**PROPOSED TECHNICAL SPECIFICATIONS FOR A 100% HELIUM RELEASE  
FROM THE BORON COATING OF THE INTEGRAL FUEL BURNABLE ABSORBER RODS  
AND A REDUCTION OF MAXIMUM PERMISSIBLE REACTOR COOLANT  
SYSTEM AVERAGE TEMPERATURE**

NEW YORK POWER AUTHORITY  
INDIAN POINT 3 NUCLEAR POWER PLANT  
DOCKET NO. 50-286  
DPR-64

**SAFETY EVALUATION OF THE  
PROPOSED TECHNICAL SPECIFICATIONS FOR A 100% HELIUM RELEASE  
FROM THE BORON COATING OF THE INTEGRAL FUEL BURNABLE ABSORBER RODS  
AND A REDUCTION OF MAXIMUM PERMISSIBLE REACTOR COOLANT  
SYSTEM AVERAGE TEMPERATURE**

FIGURE 2.1-1

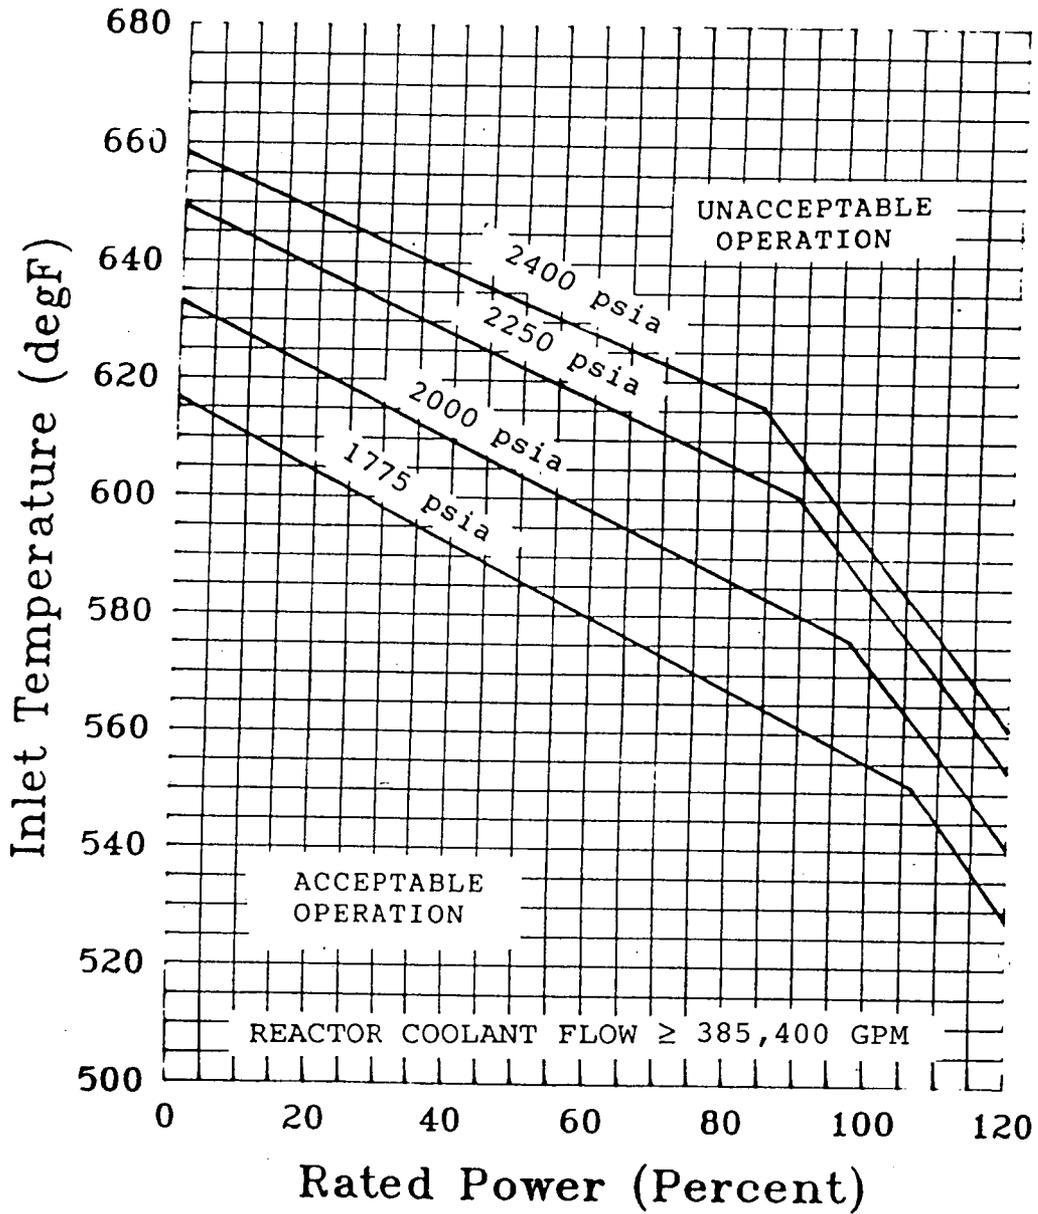
1.  $F_{\Delta H}^{RTP} = F_{\Delta H}^N$  limit at Rated Thermal Power (RTP) specified in the COLR.
2. an equivalent steam generator tube plugging level of up to 30% in any steam generator provided the equivalent average plugging level in all steam generators is less than or equal to 24%, <sup>(2)</sup>
3. a reactor coolant system total flow rate of greater than or equal to 385,400 gpm as measured at the plant,
4. a reference cosine with a peak of 1.55 for axial power shape.

When flow or  $F_{\Delta H}$  is measured, no additional allowances are necessary prior to comparison with the limits presented. A 2.6% measurement uncertainty on Flow and a 4% measurement uncertainty of  $F_{\Delta H}$  have already been included in the above limits.
